Review Assessment

Wilmington Harbor, North Carolina
Navigation Improvement Project
Integrated Section 203 Study & Environmental
Report
(February 2020)

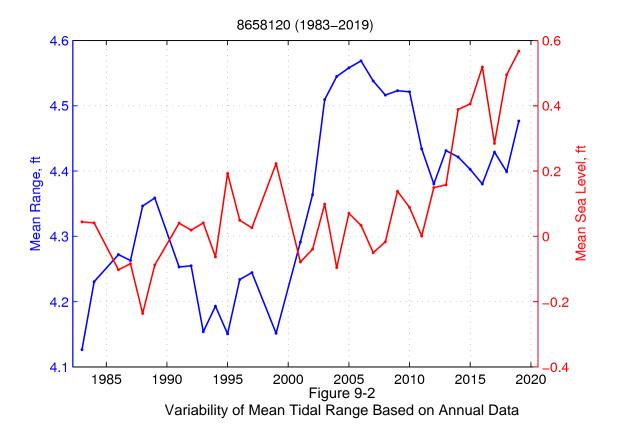
OASACW/HQUSACE Final Assessment: The comment is unresolved. In particular, the response states that "The change in tidal range is not due to climate effects, but rather due to the alteration of the Cape Fear River Estuary by federal navigation projects over the past 150 years. Thus, this trend in MHHW (and tide range) should not be expected to continue in the future in the absence of any future navigation projects and should not be used as the future sea level for the FWOP and FWP conditions." In fact, this project will exacerbate the situation by deepening the channel further with potential nonlinear increases in tidal prism upstream. Risks to shoreline development, bridge clearance, if any, coastal flood risk reduction measures, if any, and the performance of gravity drainage infrastructure, should be addressed. Where these systems were federally-funded in whole or in part, this project cannot reduce their design performance. A description of the potential issues and any necessary adaptation measures is sufficient.

As shown in Table 9-5 and Figure 9-2 the rate of increase during the aforementioned time periods for MHW and MLW is similar to the rate of increase of MSL. Specifically, it was observed that MHW is increasing at a slower rate (by 15–20%) than MSL during the periods when no major alterations were made to the river channel.

Table 9-6 shows a notable change in the mean tide range as a result of the channel improvements that occurred between 2000 and 2004. This is especially clear in Figure 9-2 based on yearly data. Figure 9-2 a significant but gradual increase in the tidal range which occurred between 2000 and 2004 due to the most recent channel deepening / widening project.
